# SERVICE BULLETIN

SUBJECT: TS-180S IF OUTPUT #2 LEVEL CHANGE FOR SM-220 OPERATION

DATE 7/10/79

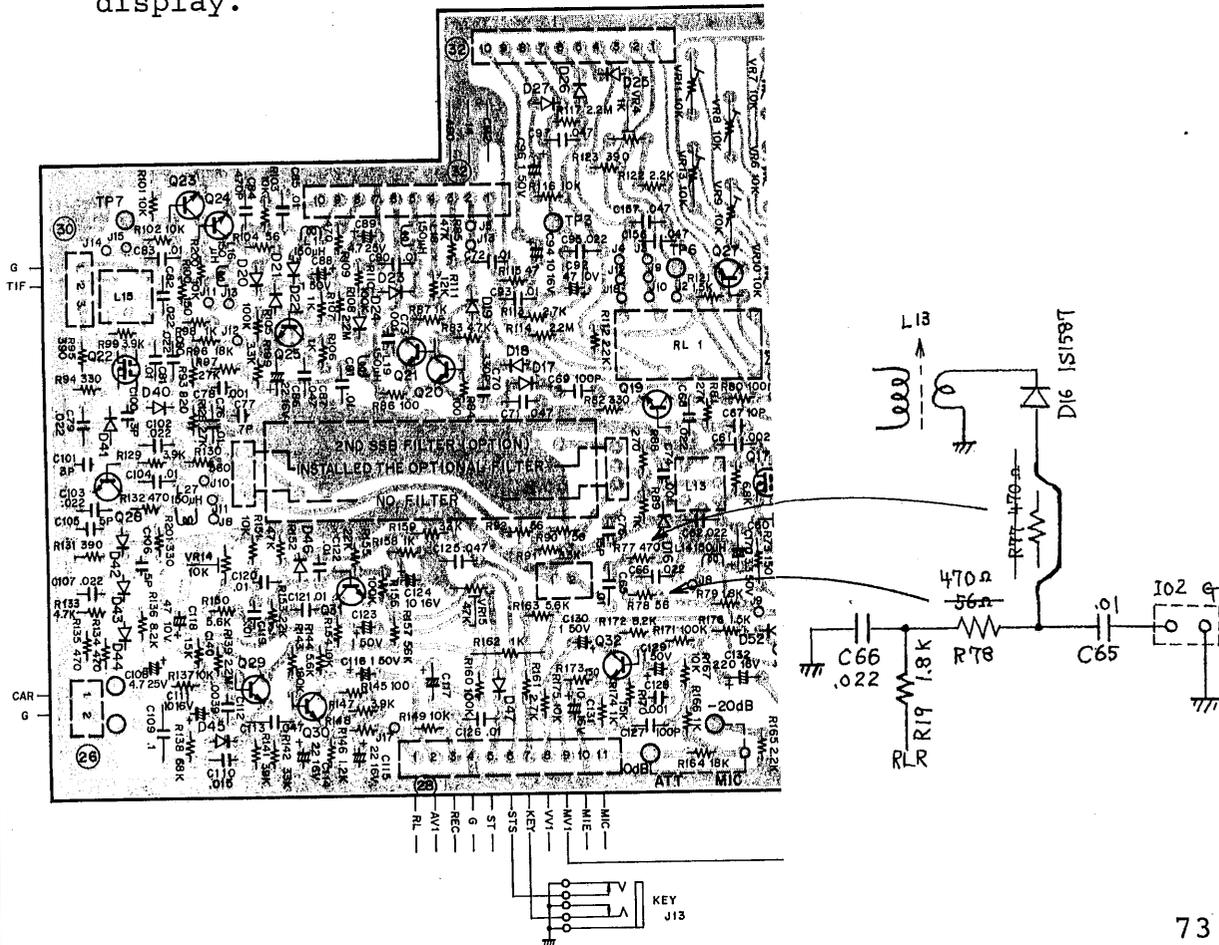
TS-180S owners who desire to operate an SM-220 for IF output display will require a wiring change to the IF unit X48-1240-00. No additional parts and no adjustments are required.

Remove R77, 470 ohm, and replace with wire jumper. Remove R78, 56 ohm, and replace with old R77. The 56 ohm resistor is not used.

With AGC on, gain should be adequate for about a 3/4 screen display.
